August 11, 2022

RE: Harbor Grove – First Review SD-2021-001/ENG-2021-019/SEPA-2021-010
BlueLine Job No. 21-073

RE: Harbor Grove – Comment Response to Hydrology Report Requirement
Permit No. ENG-2021-019
BlueLine Job No. 21-073

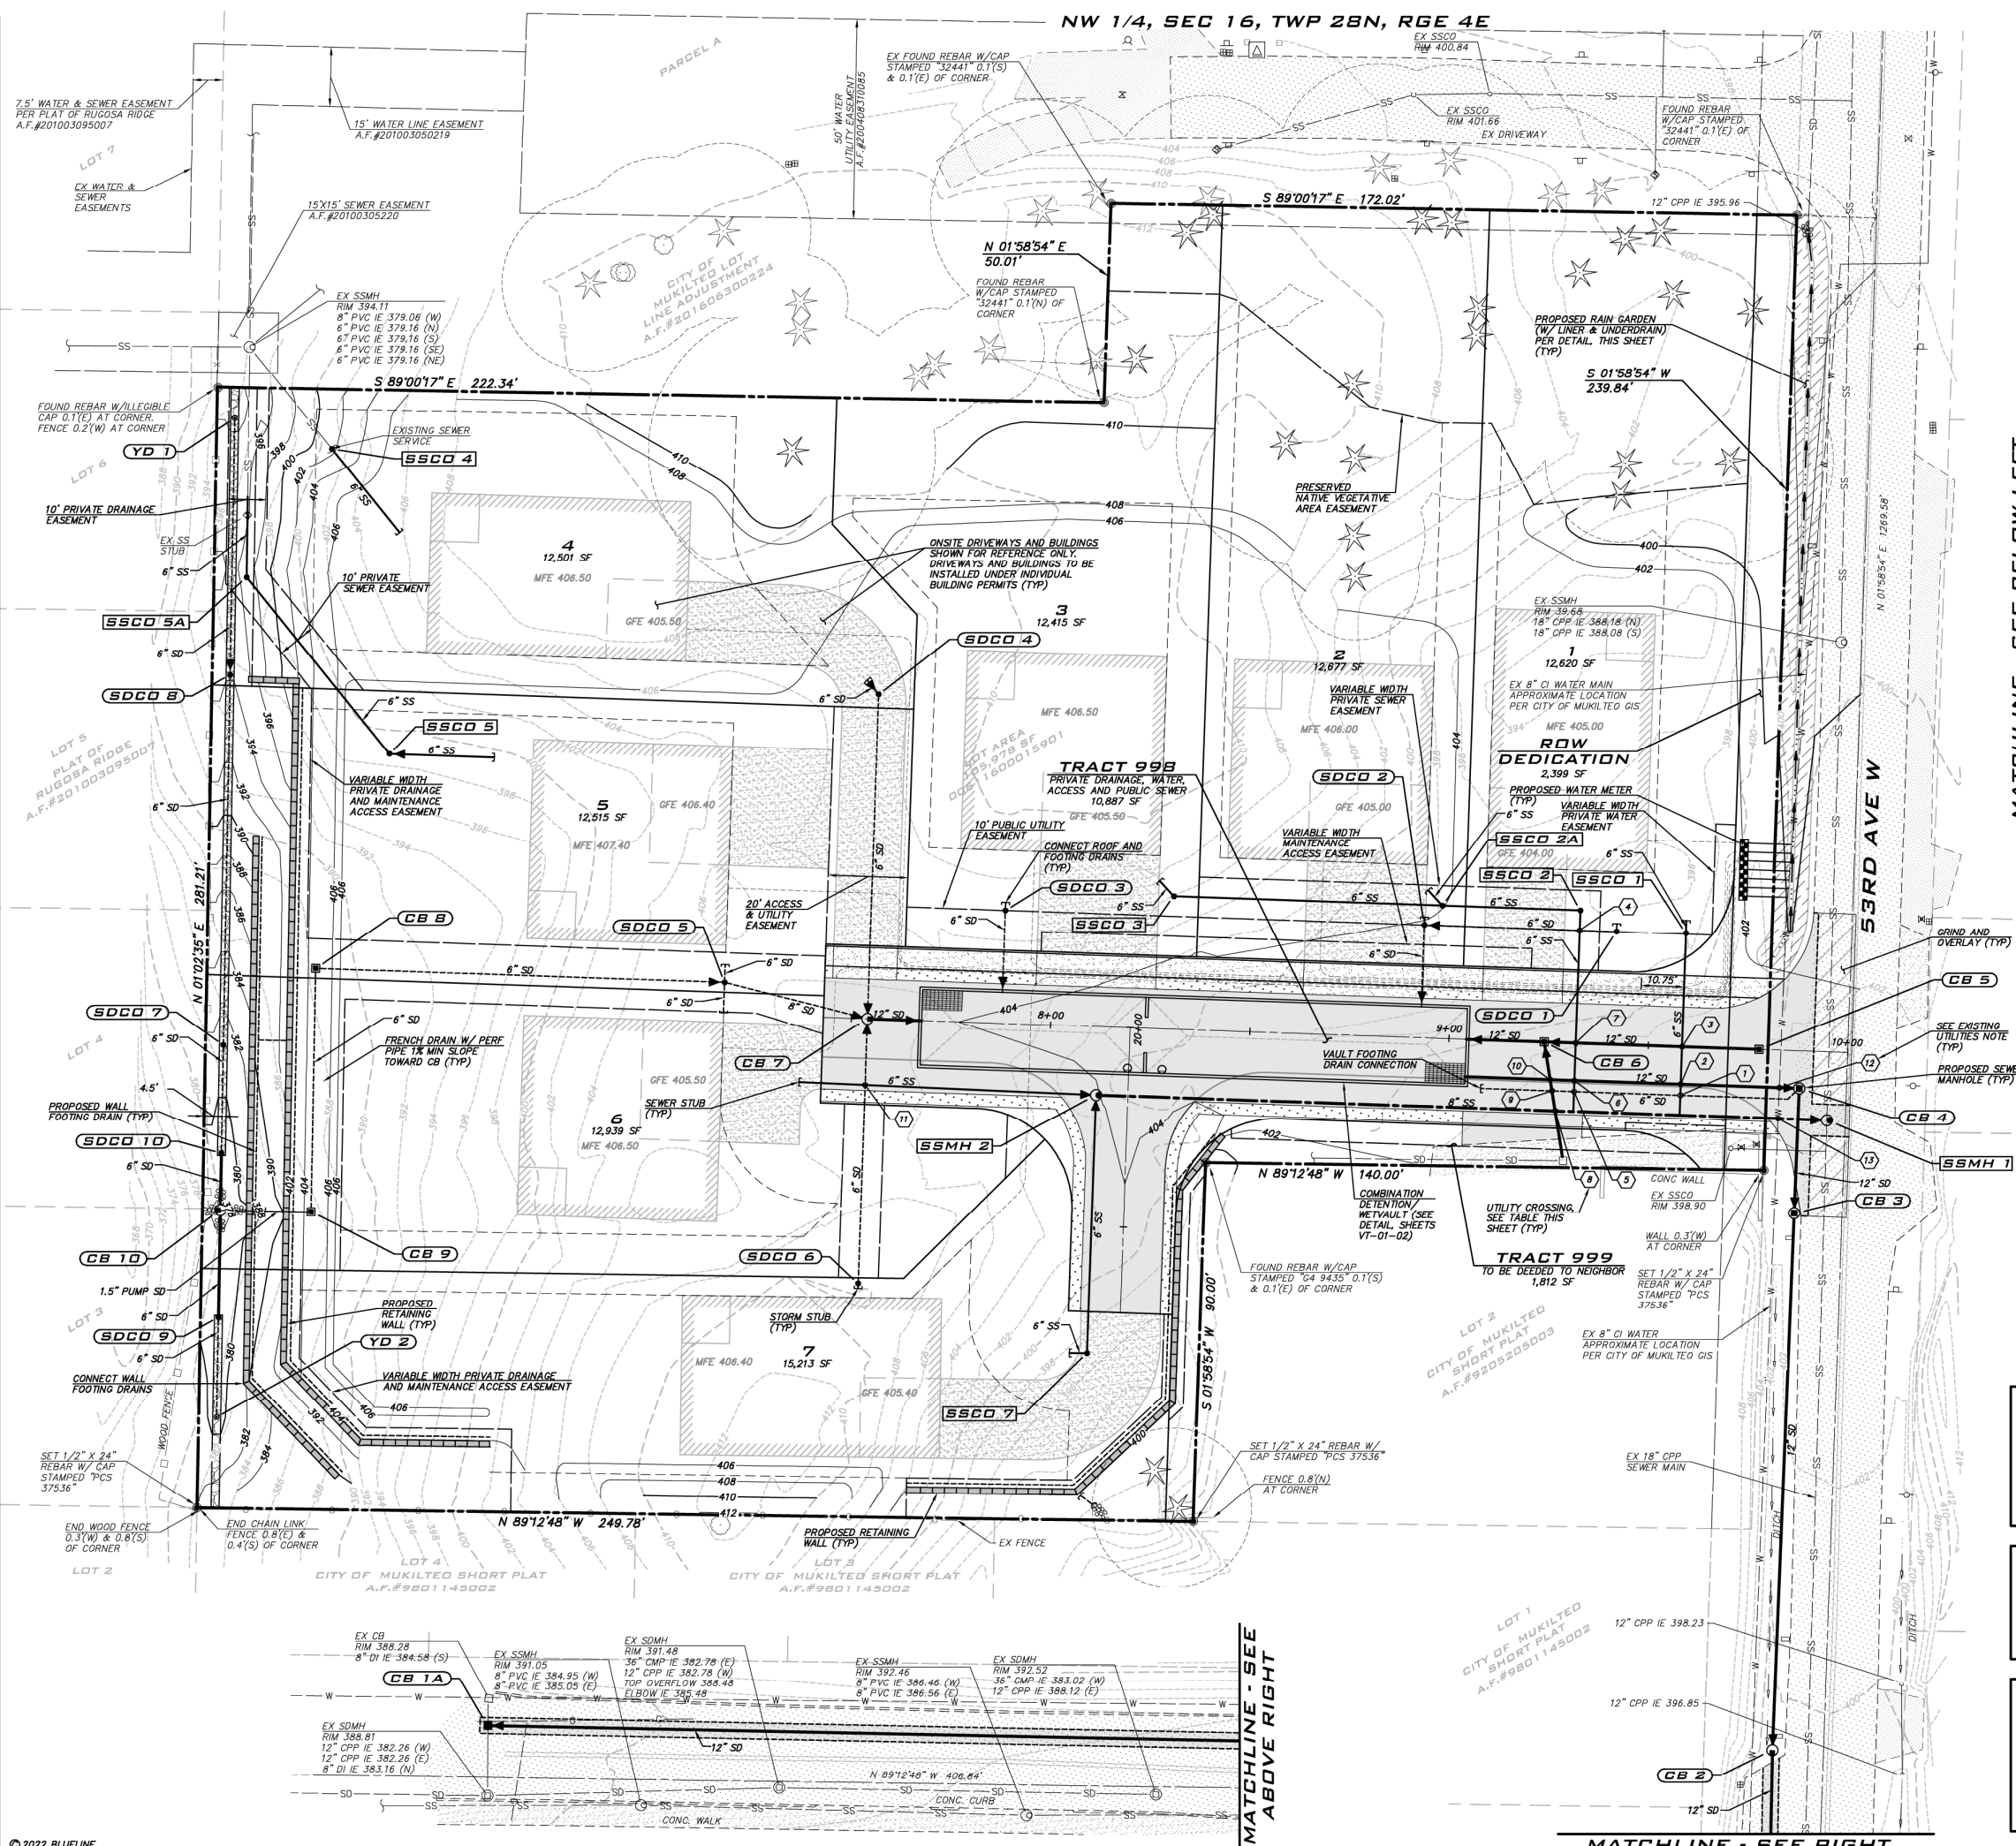
Per Comment #7 on Page 8 of the City of Mukilteo review letter dated February 17, 2022, a "hydrology report for clearing on slopes greater than 35% is required by MMC 15.16.050.C.2.b.i(b). There appears to be slopes greater than 35% along the southern perimeter of the property. The report must satisfy the requirements of MMC 15.16.060.D.6 and D7. Public Comment No(s): (12)(16)." Code language from MMC 15.16.050.C.2.b and i.(b) is provided as follows:

We believe that MMC 15.16.050.C.2.b.i(b) does not apply to the subject project. Refer to Exhibit A (attached on the following pages) for a slope map delineating the existing slopes that exceed 35% to be cleared in the developed condition.

The project proposes to fill and flatten majority of the parcel. Onsite runoff will be collected and conveyed via a tightlined system, ultimately discharging to the storm system within 92nd St SW. Existing onsite slopes exceeding 35% within the project's clearing limits will be regraded to be less than 35%, stabilized, and revegetated utilizing Post-Construction Soil Quality and Depth per BMP T5.13 of the 2019 Stormwater Management Manual for Western Washington. A copy of BMP T5.13 is included at the end of this letter. Existing onsite slopes exceeding 35% will remain undisturbed in the developed condition.

Based on the information provided, the proposed grading and drainage design is anticipated to provide an improved onsite management of stormwater flow.

SHEET NAME:
CU-01

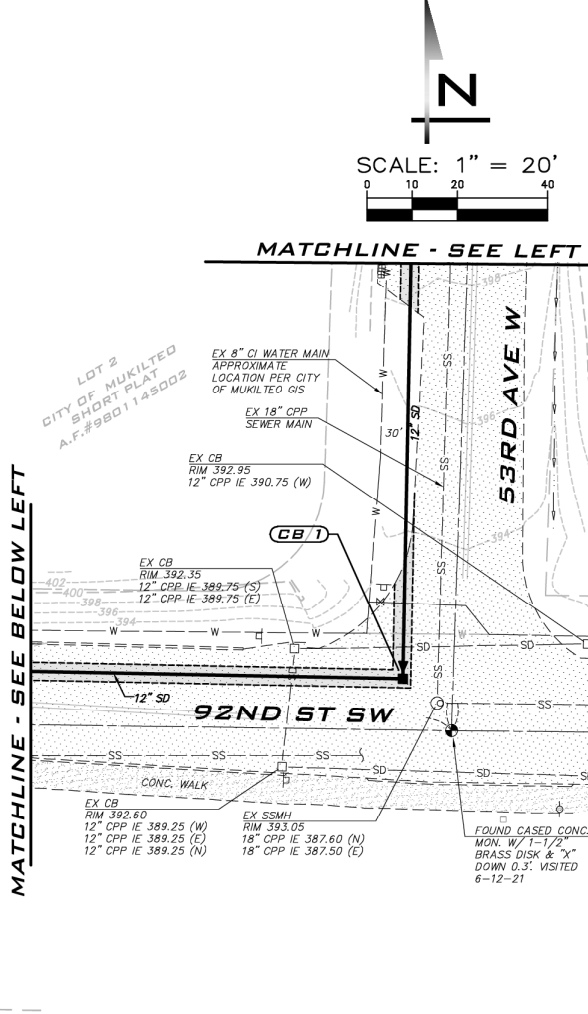
The following letter is provided in response to a City of Mukilteo engineering comment with regards to the project Harbor Grove, permit ENG-2021-019. The project proposes subdividing the existing parcel into 7 single-family lots, an access/utility tract, and a tract to be deeded to Parcel #00611600015902. Proposed improvements include construction of private access and utility services. Access to the project will be provided via 53rd Ave W. See Sheet CU-01 for a utility site plan provided at the end of this letter.
